CERTIFICATE OF HIGHWAY MILEAGE
YEAR ENDING FEBRUARY 10, 2010

**Mileage Certificate Change 2010
CHESTER**

CHESTER NOTES
17-18 Mar 2010

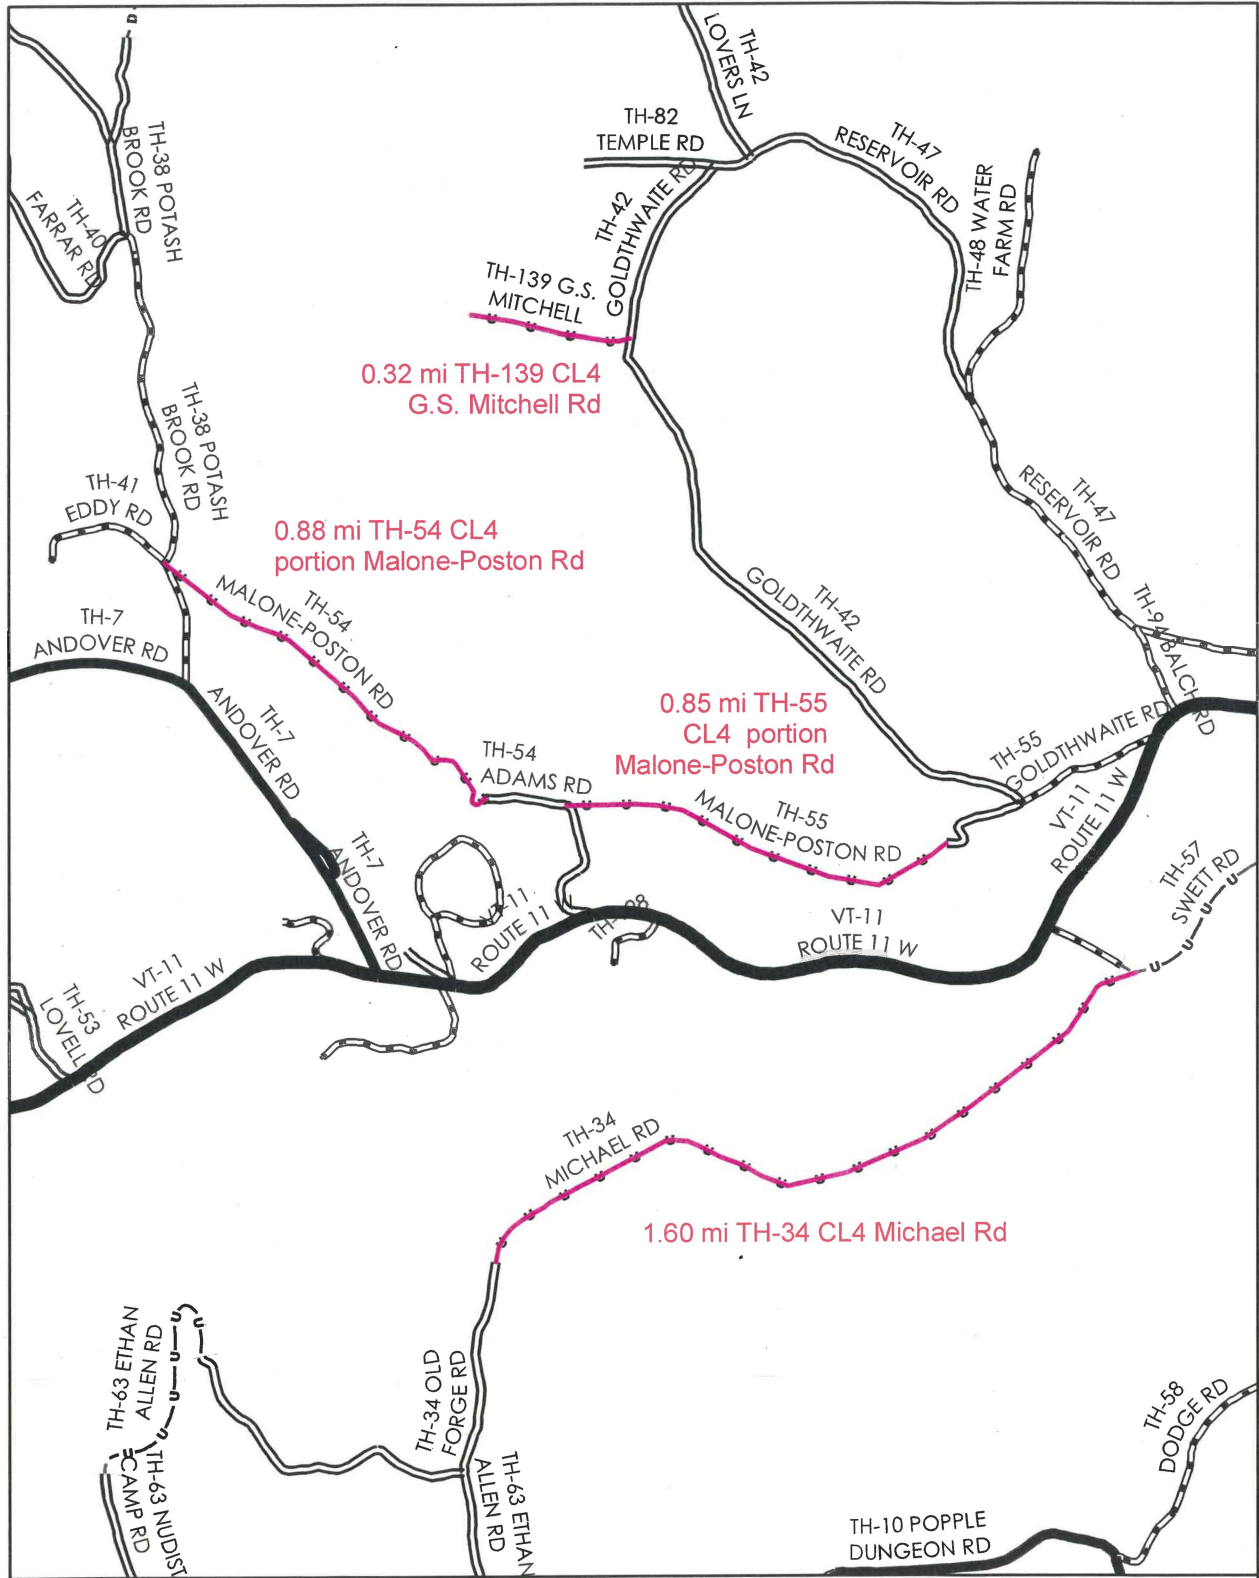
1.09 mi TH-136 CL4
Bailey Hill Rd

0.60 mi TH-141 CL4
Smokeshire Cemetery Rd

Mileage Certificate Change 2010
CHESTER

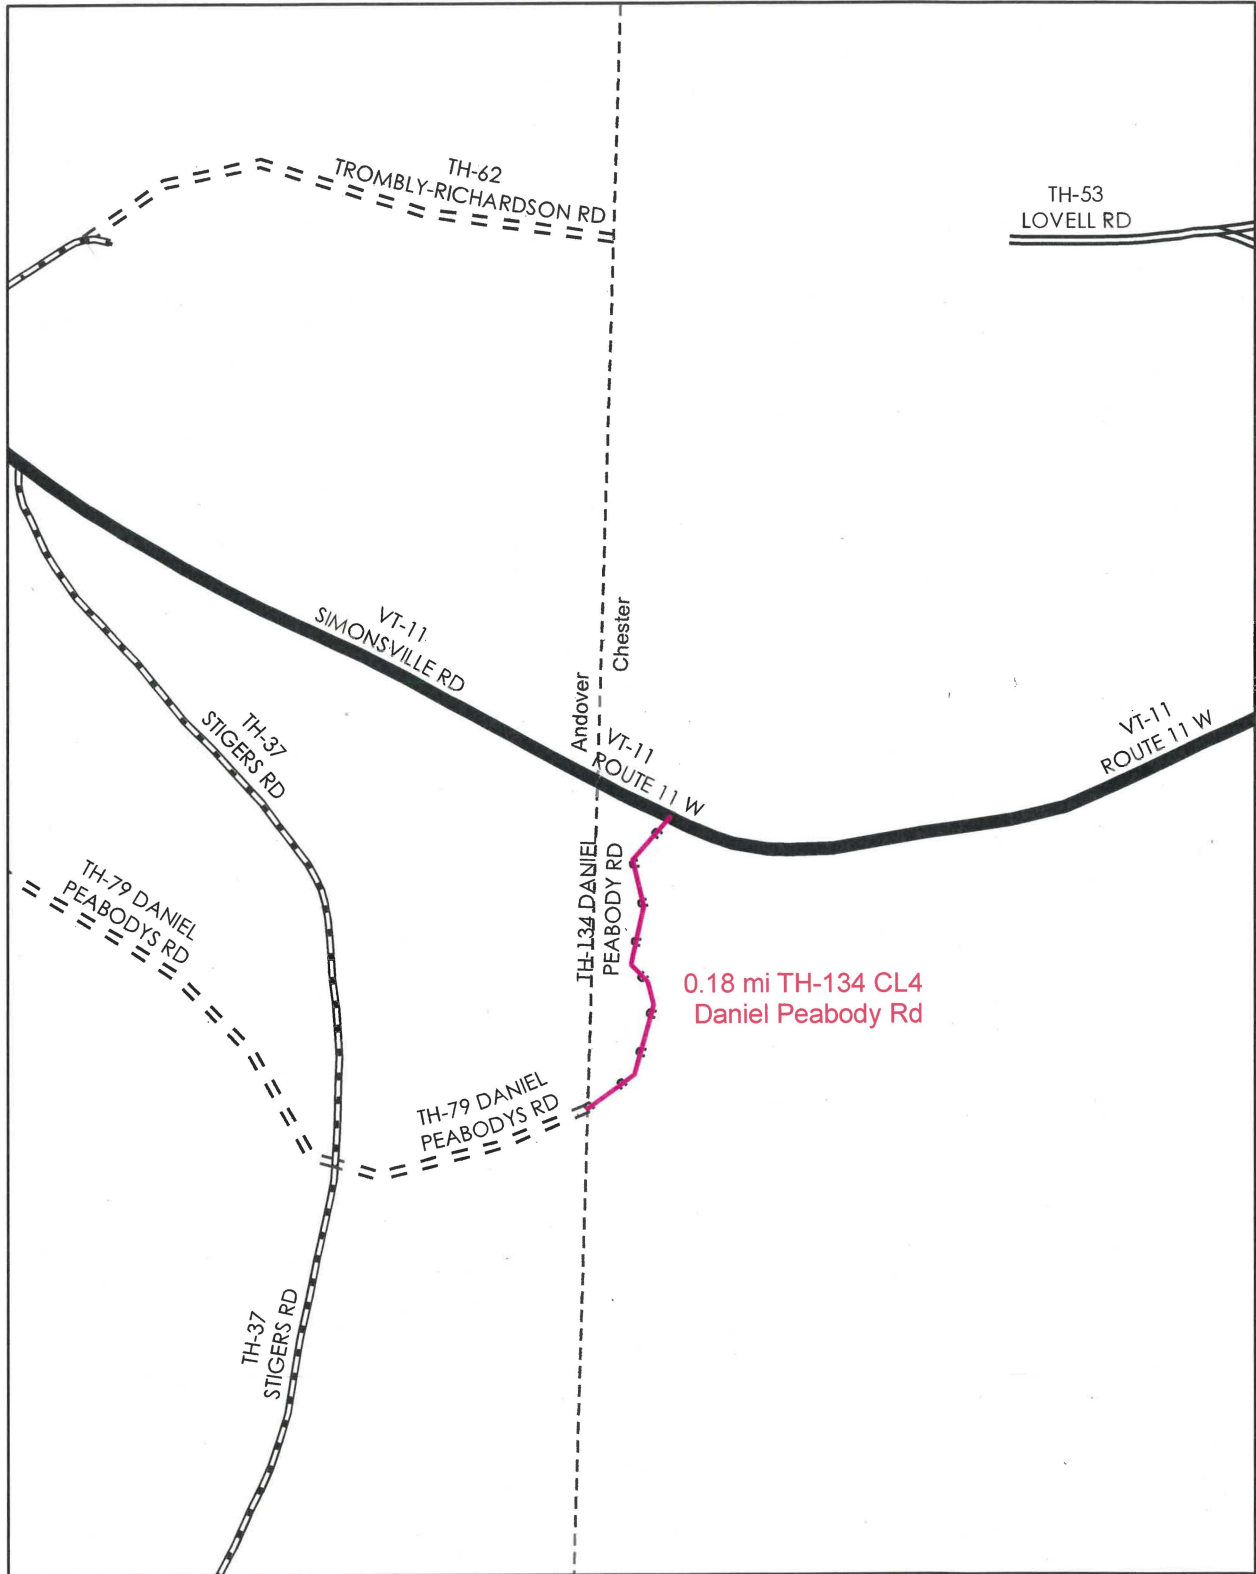
0.20 mi TH-65 CL4 Contro Rd
